| DEV NUMBER:<br><b>DEV25-0024</b>  |  | ORIGINATOR:<br><b>Xavier Vela Lopez</b>  |  | DATE:<br>5-Feb-25             |  | <b>RAIN BIRD</b>   |  | BUSINESS UNIT (SBU and PLANT) W/ PRIMARY DESIGN CONTR  |  | SHEET:<br>1 OF 1                                     |  |
| DMR# (IF APPLICABLE):   |  | DEVIATION NEW <input checked="" type="checkbox"/><br>TYPE: EXTENSION <input type="checkbox"/> OF DEV#: |  |                               |  | <b>DEVIATION FORM (DRAWING)</b><br>FORM#233813-01 REV: R |  | 025 OTY >>> COM  |  |  |  |
| 183529  |  | F  |  | F1                            |  | SCREEN TAPERED   |  | KAS  |  | OTHER:   |  |

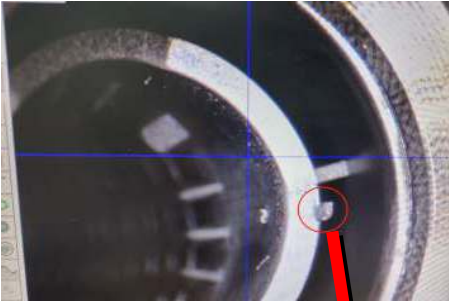
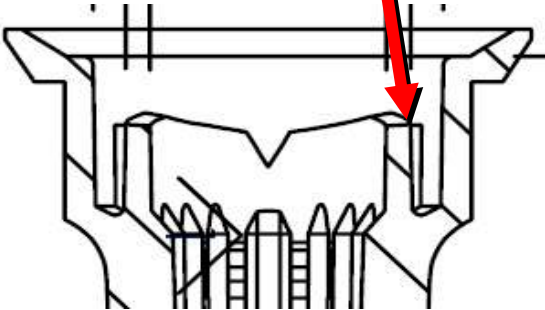
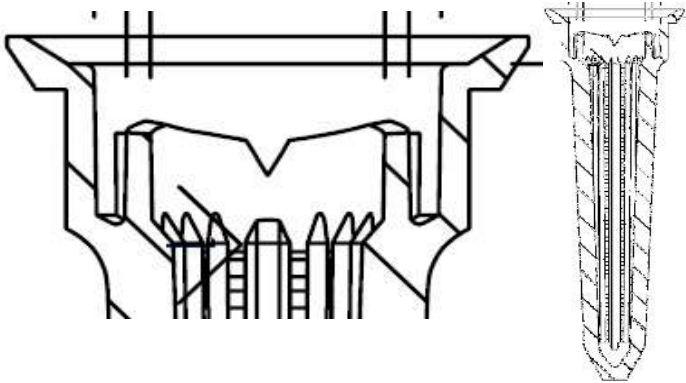
| REASON FOR DEVIATION:<br><br>Allow KAS production and shipment of 710,000 units of 183529 M44017 (Screen Tapered) based on the condition described below. This is due to a flash condition caused by material being dragged in the tool.  |  |  |  |                               |  |  |  | APPROVALS (ALL REQUIRED):  |  |  |  |
| DESCRIPTION OF DEVIATION (IS/WAS CONDITION AND DRAWING ZONE FOR EACH PART NO. OR ATTACH REDLINE PRINTS):  |  |  |  |                               |  |  |  | QUALITY DIRECTOR (REQUIRED FOR BACK-TO-BACK DEVIATIONS)  |  |  |  |
| IS: 6. MAX FLASH APPENDAGE TO BE .020 High X .020 Thick WAS:  |  |  |  |                               |  |  |  |  |  |  |  |
|   |  |  |  |                               |  |  |  | 6. MAX FLASH APPENDAGE TO BE .007 HIGH X .005 THICK  |  |  |  |

| RISK ASSESSMENT/ CORRECTIVE ACTION PLAN (NAMES & DATES)/ COMMITMENT:<br><br>Low: Area were flash is present there is no interaction with other components and it doesnot interfere with water flow, additional material wont come loose or cause issue due to its size.<br>Action Plan:<br>- Built inventory 710K Oscar Santillan / KAS 2/20/25<br>- Disassemble this tool and inspect all the cores. Larry Perkins 3/7/25<br>- Build new cavities Larry Perkins 4/11/25<br>- Install and validate KAS / Larry Perkins 5/9/25 |  |  |  |                               |  |  |  | QUALITY MGR. OR QUALITY ENG.<br>Ramiro Casas / Jose Luis Montero   |  |  |  |
